Northern Link Environmental Impact Statement Supplementary Report

APPENDIX B RESPONSE TO SUBMISSIONS

■ June 2009

- Figure B-10 Predicted Roadside Concentrations near Surface Ramps on Milton Road for the EIS Reference Project.

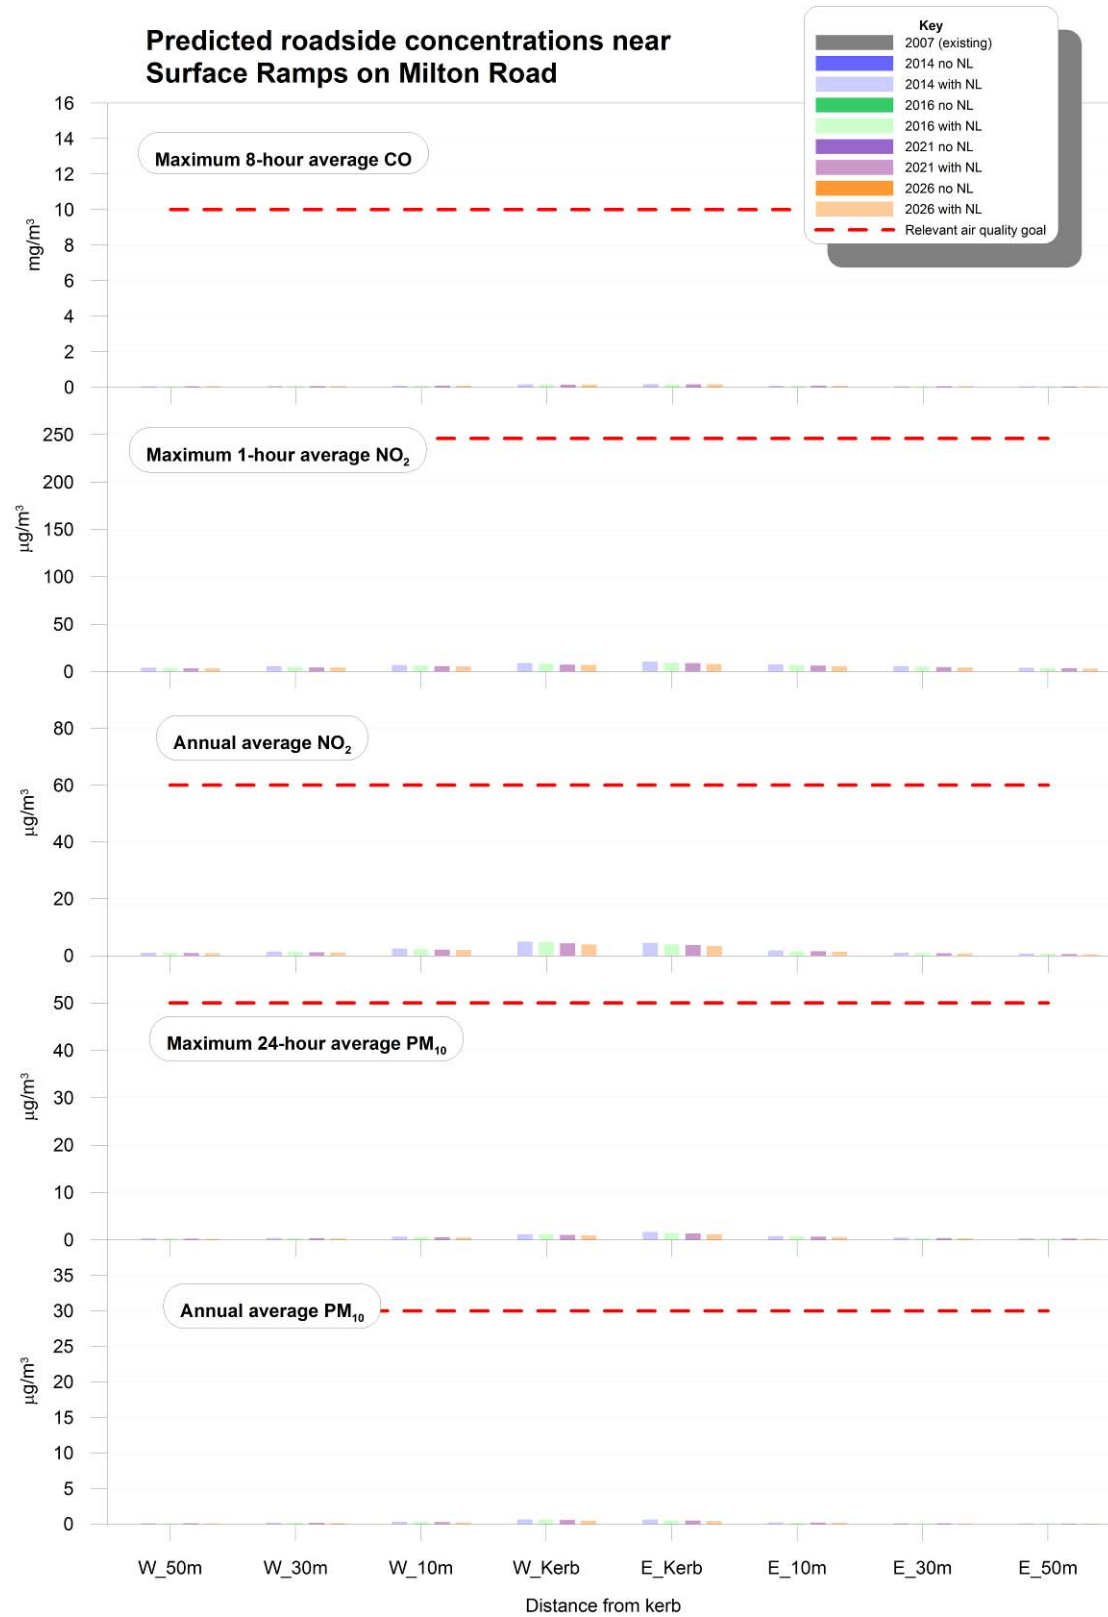
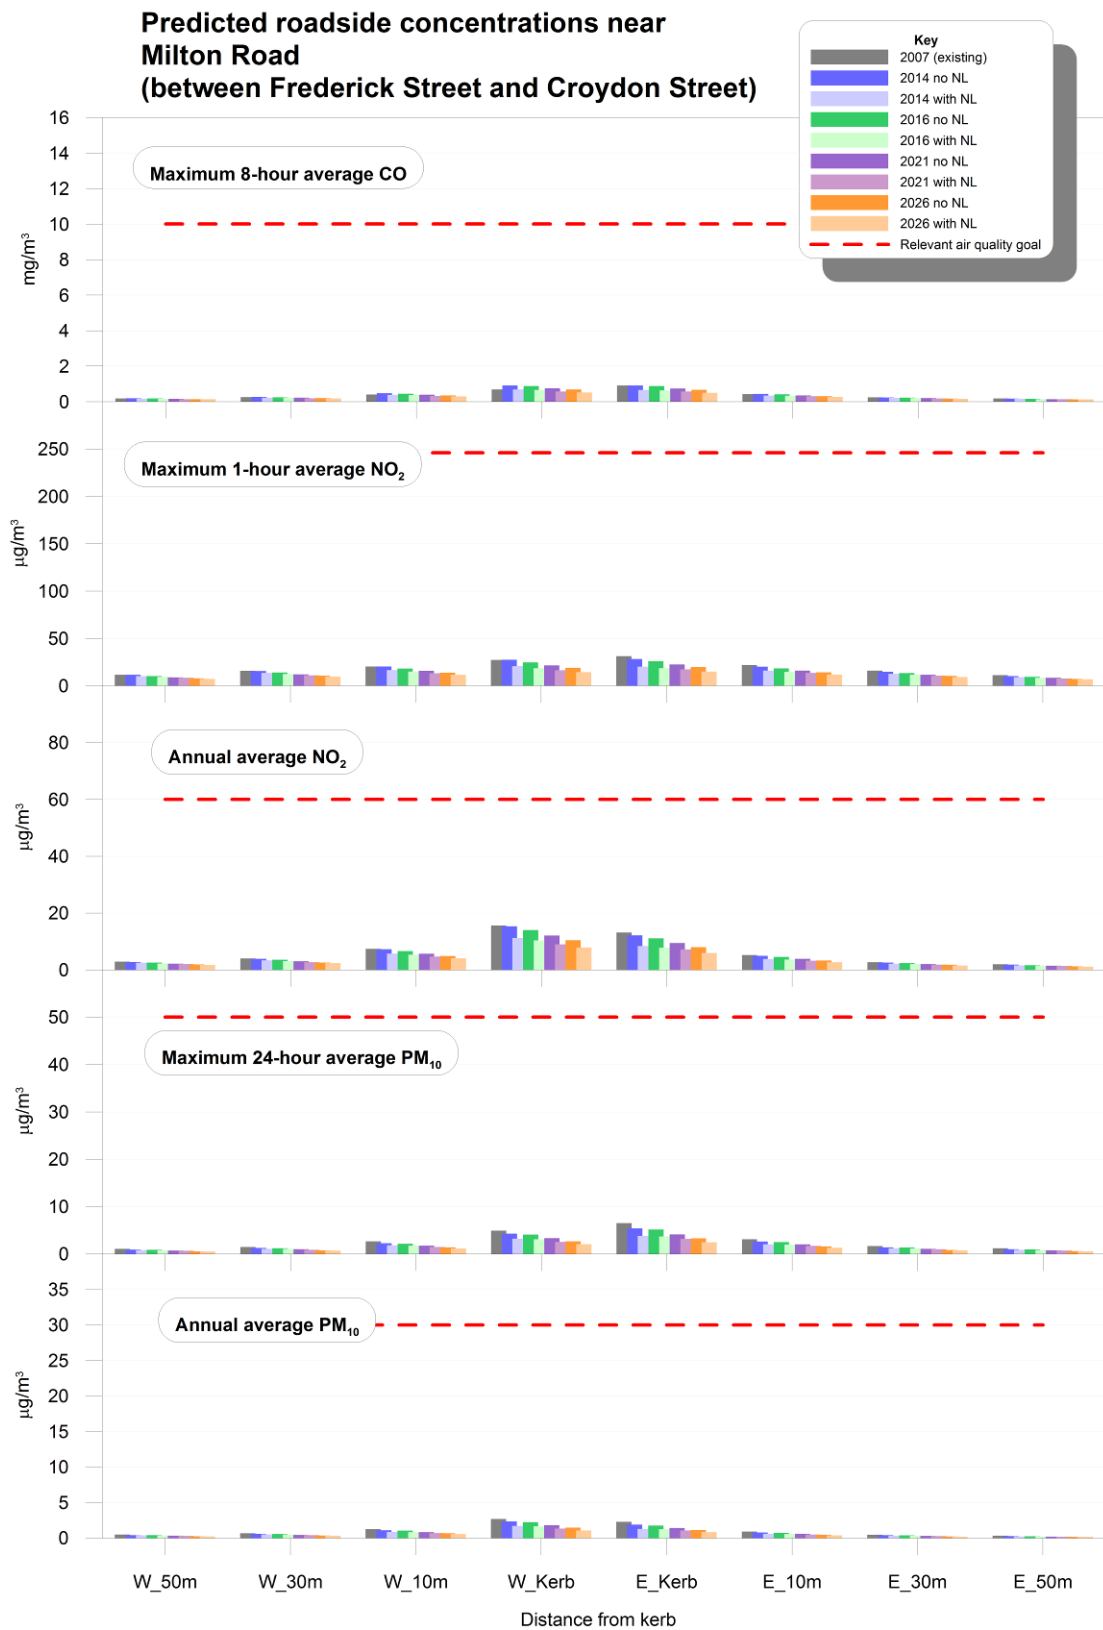
Some submissions raised concerns that ambient air quality in the vicinity of the Toowong State School would be diminished as a consequence of Northern Link. The modelling for Sylvan Road, between Croydon Street and Milton Road, provides relevant predictions of ambient air quality adjacent to the school. The predicted changes indicate minimal to negligible decreases in the concentrations of both nitrogen dioxide and particles (PM₁₀) in response to a forecast minimal reduction in traffic flows on this section of Sylvan Road.

Council has decided to remove the local connections with the effect that there will be minimal to negligible change in detectable ambient air quality associated with forecast changes to local traffic within the areas noted in the submissions.
